# U-6A / NU-1B Technical Support Contract

## Technical Assistance Activity Accomplishment Report

June 2002

# ***CONFORMITY INSPECTION REPORT***

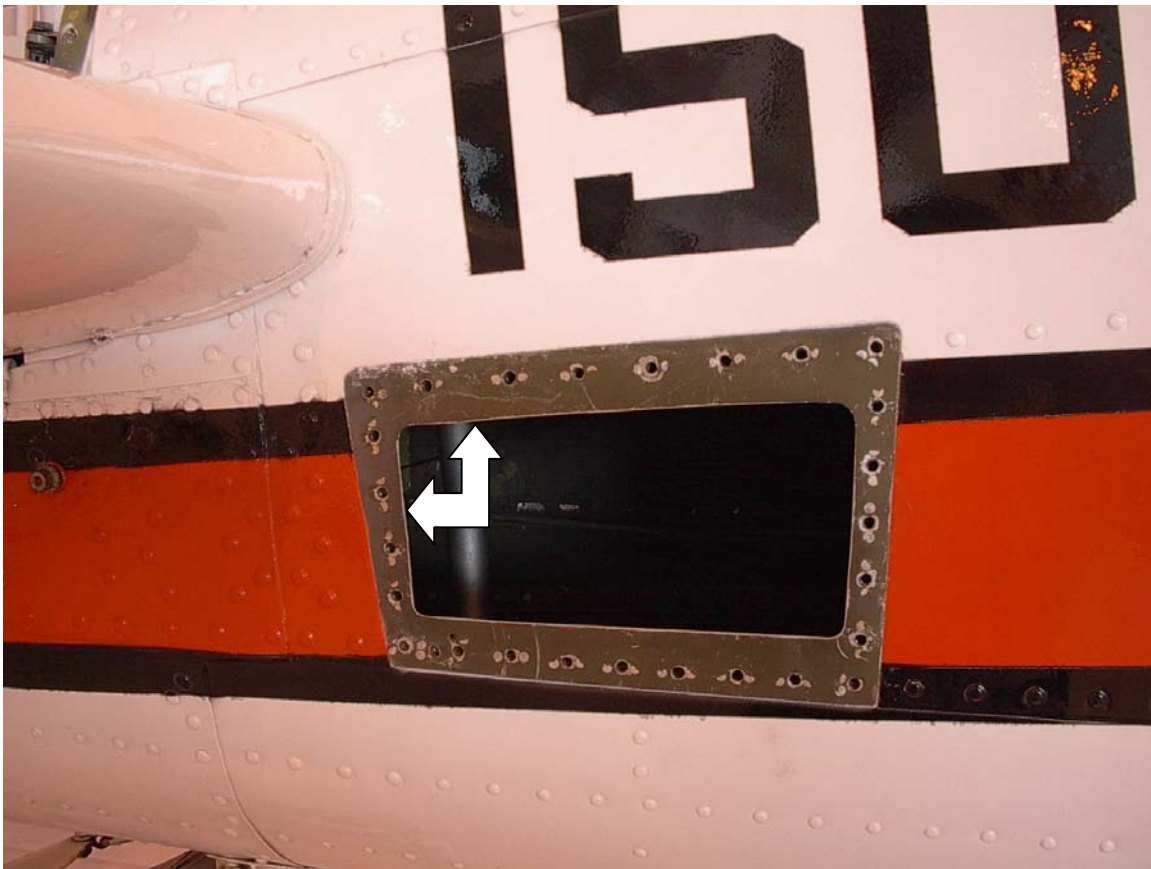
8. Unapproved air speed indicator installed. Must be range marked per DHC-2 Flight Manual.

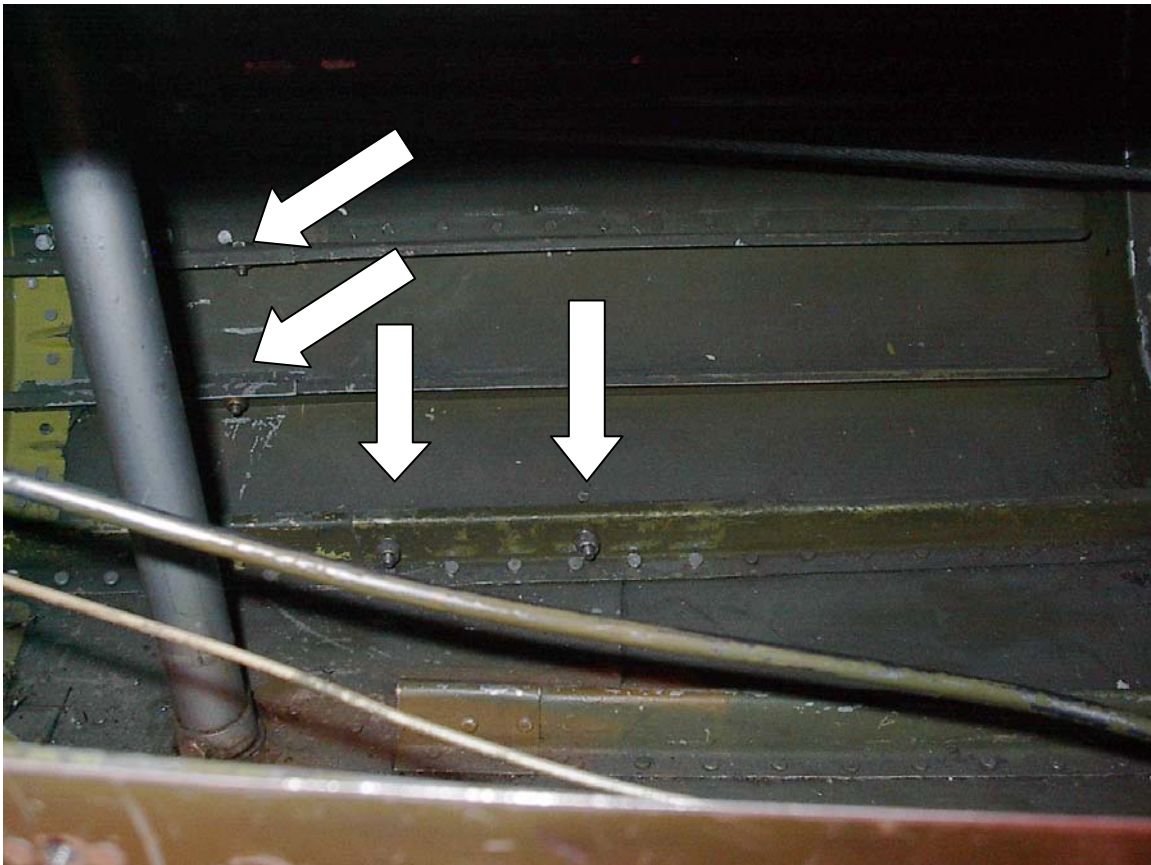
**19. Unapproved repairs (bolts in stringers) in tail section between STN 208 and STN 228. Reference DHC-2 Repair Manual Figure 4-9.**

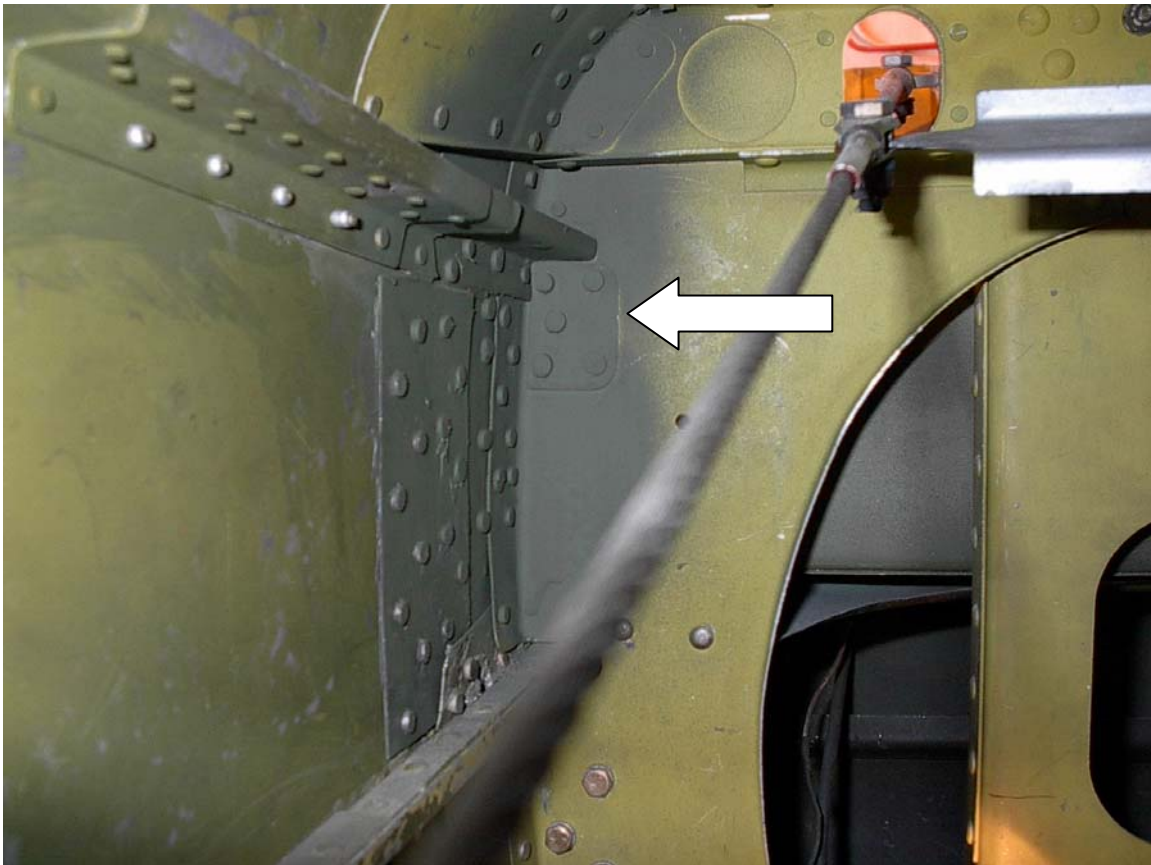
**20. Structural support brackets (P/Ns C2FS5215/16) for tailplane pick-up missing.**

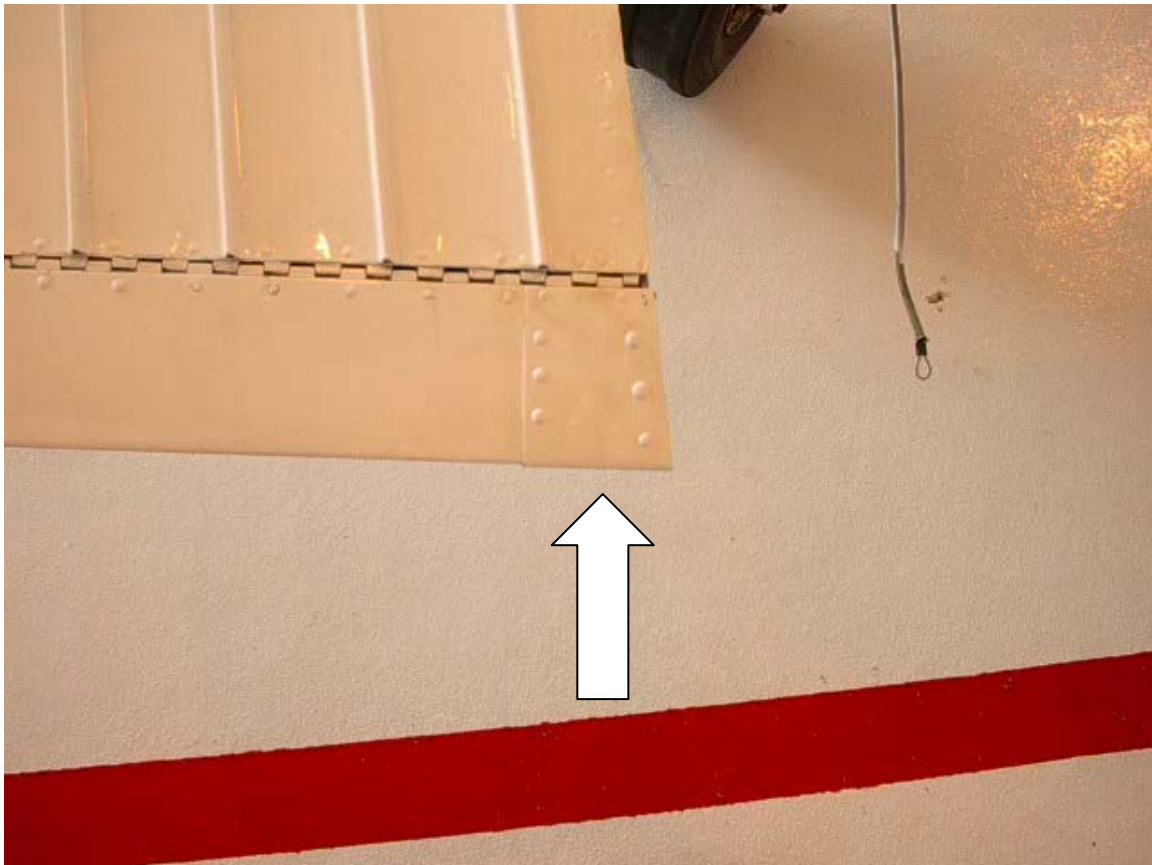
**29. Several rivets are not properly bucked inside the horizontal stabilizer center section.**

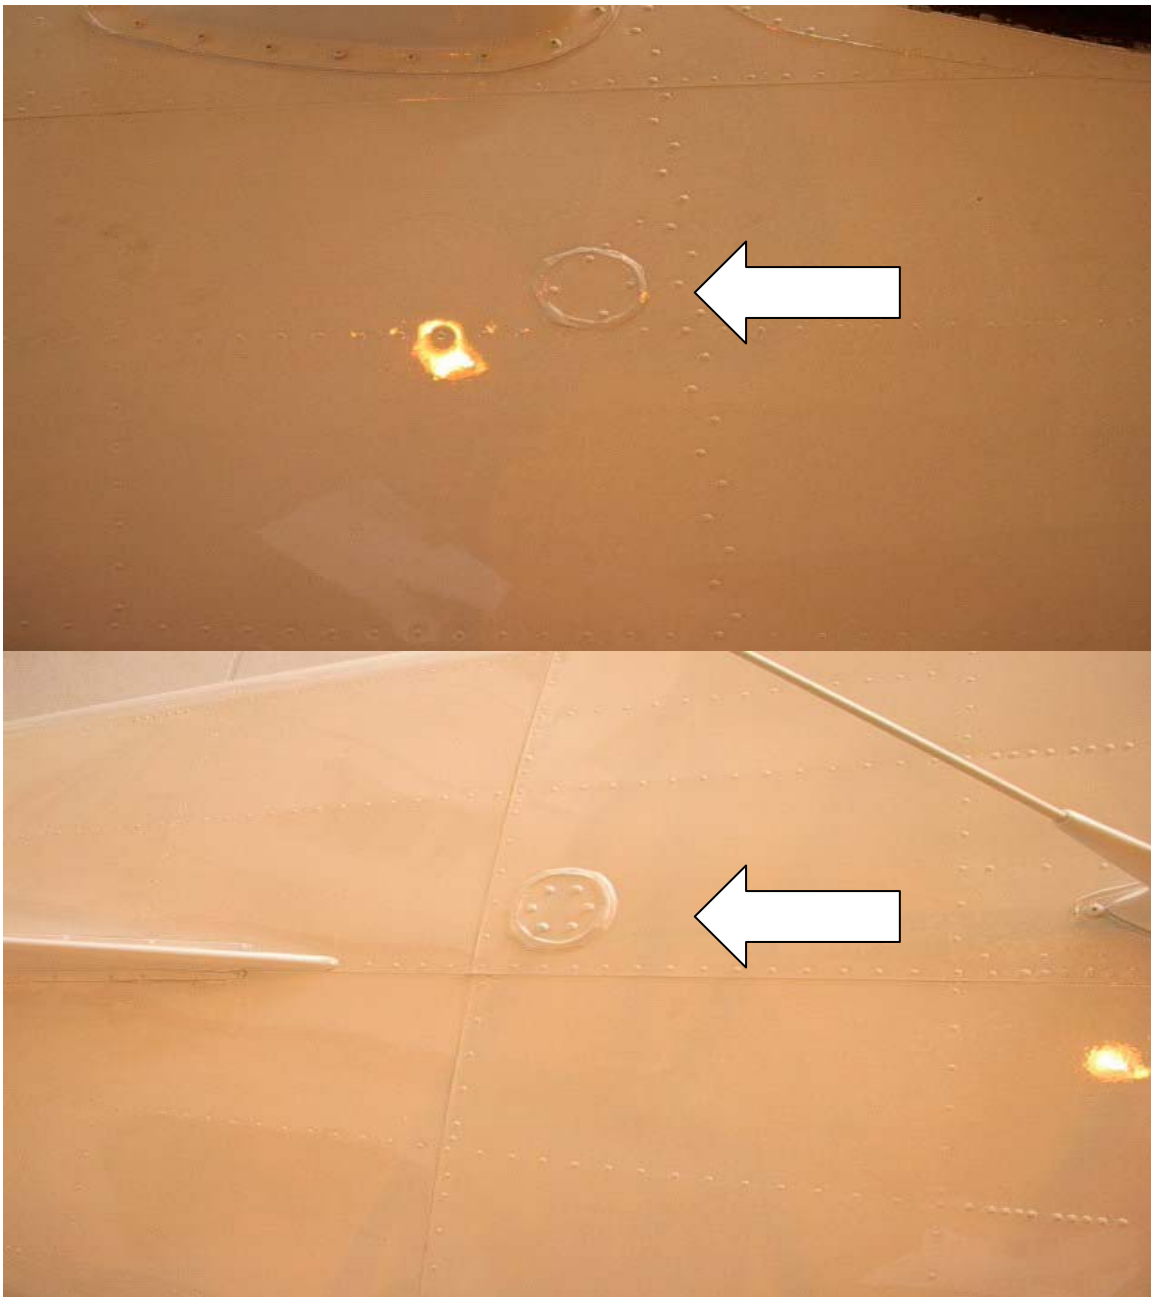
32. Stringer cracked/torn inside tail section, right side, STN 228.

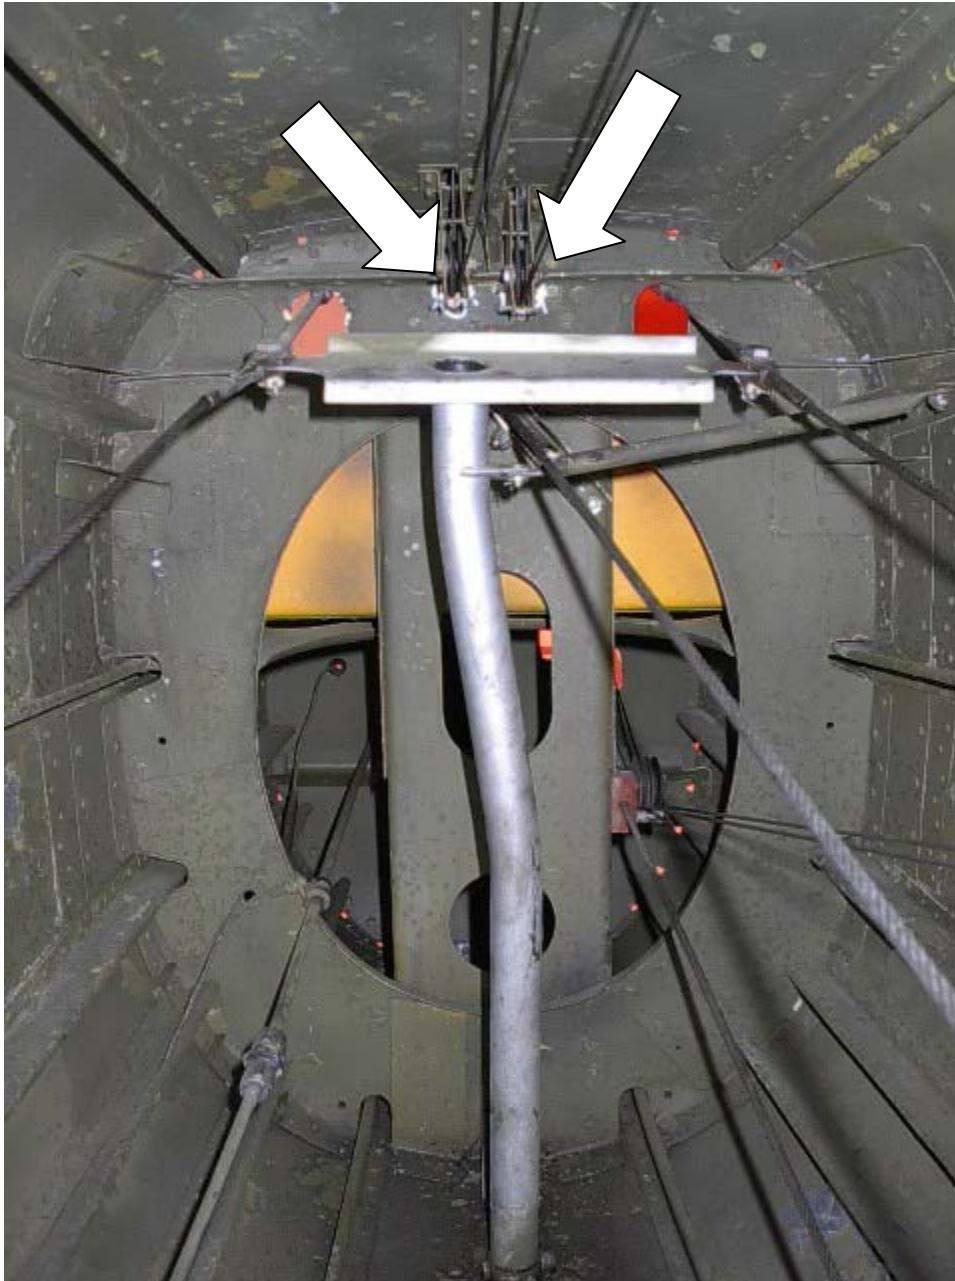
**18. Aft fuselage channel, P/N C2FS405A at the top of STN 228 is cracked at rudder horn attach bolts.**

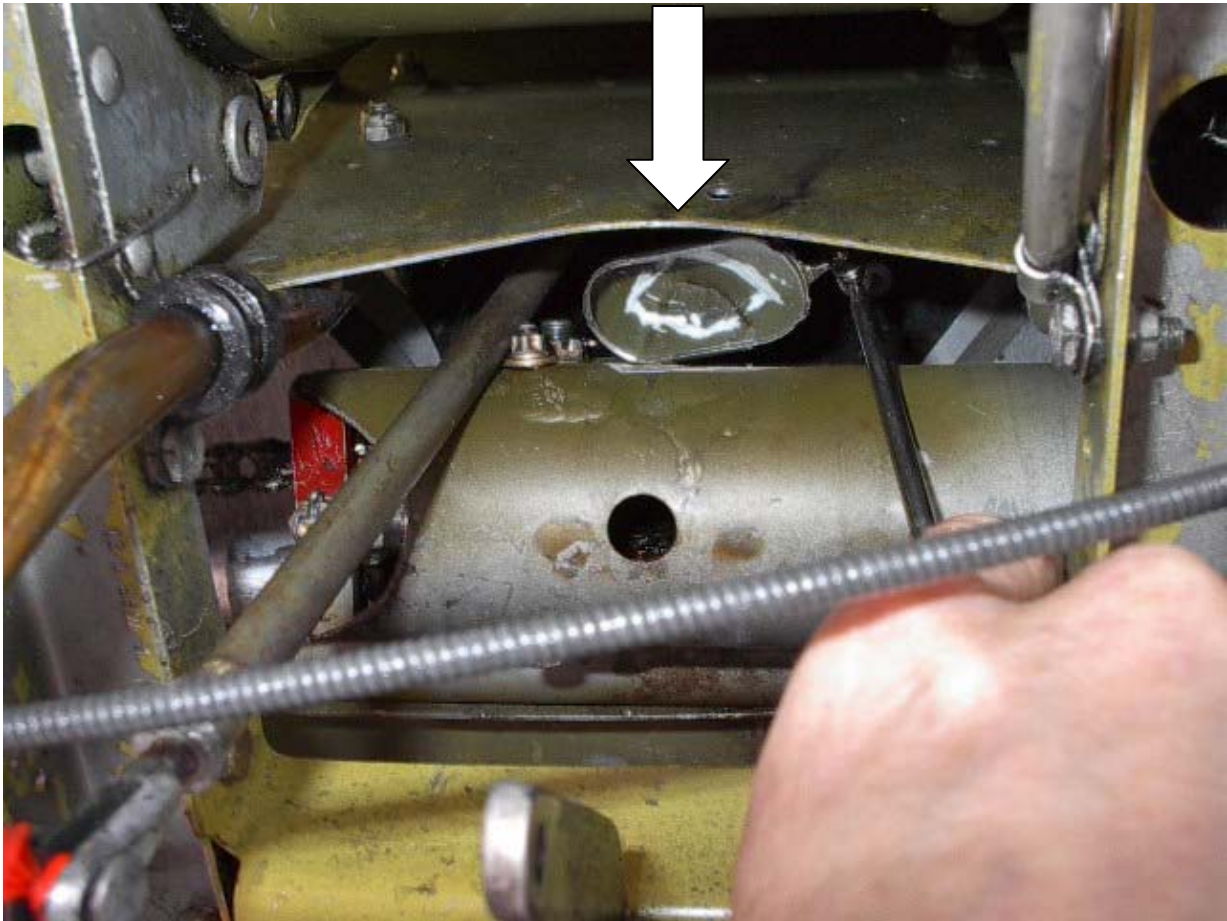
30. Left elevator has two (2) unapproved repairs on the inboard upper skin, reference DHC-2 Repair Manual Section 3, paragraph 3.17.
